22 ESBWR PRA Changes

22 ESBWR PRA CHANGES

Section 22 provides a process to document and evaluate changes to PRA parameters that occur after the PRA modeling details are frozen and incorporated into NEDO-33201. New information from technical reviews, operating experience, or other feedback mechanisms is evaluated for its effect on PRA parameters. Subsections correspond to the main report, for example, changes to the flooding PRA would be found in subsection 22.13.

Figure 22.16.4-31. (Updated) LOCA – RWCU Break Outside Containment (Mode 5)

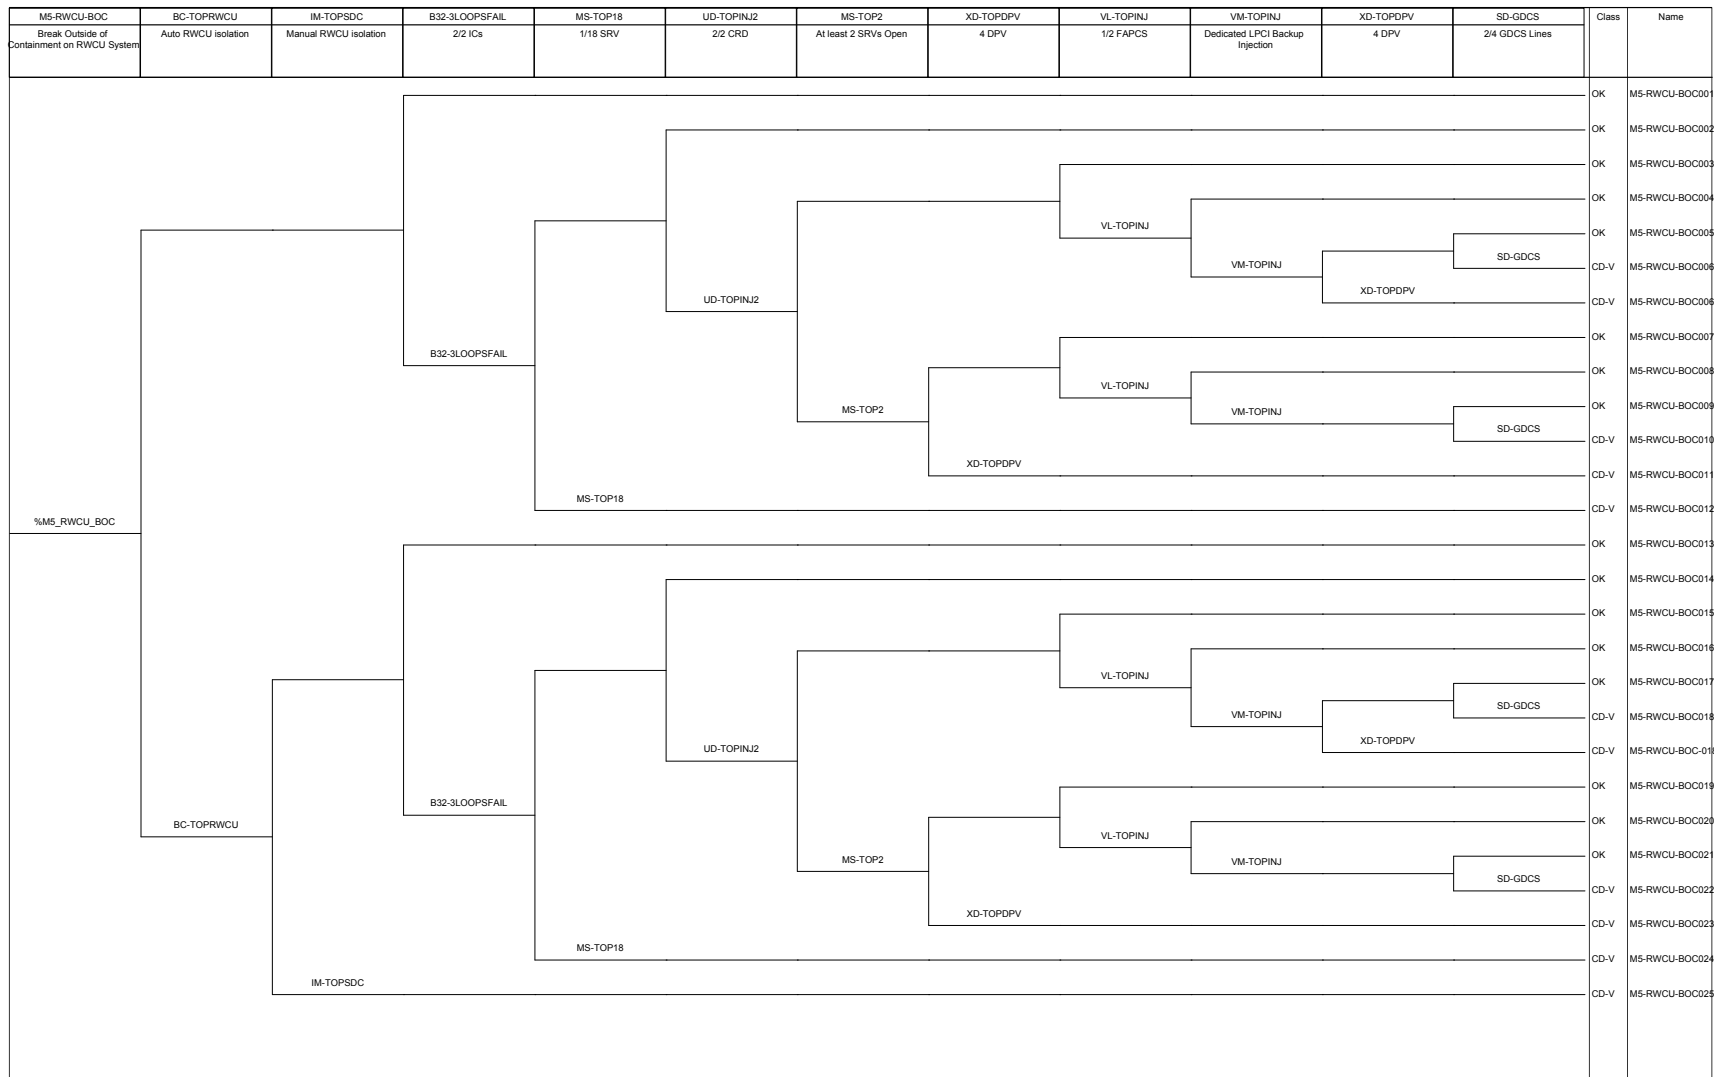
The RWCU/SDC Break Outside of Containment (BOC) event trees have been modified to include a top event for four DPVs actuating prior to GDCS actuation. This modification makes the RWCU/SDC BOC trees consistent with other shutdown (SD) PRA event trees. This change slightly increases the SD risk values since new sequences are added. However, the contribution from these new sequences is negligible because they involve multiple failures of the injections systems. The Mode 6 event trees do not require depressurization, so this change has no impact on event trees “M6F-RWCU-BOC.eta” and “M6U-RWCU-BOC.eta”.

The updated Figures 22.16.4-31 and 22.16.4-32 for the RWCU BOC event trees for Mode 5 and 5 Open are shown as below. In the Mode 5 and Mode 5 Open event trees, top event XD-TOPDPV has been added before top SD-GDCS. Four new core damage sequences are generated, which are also classified as CD-V (i.e., bypassing the containment):
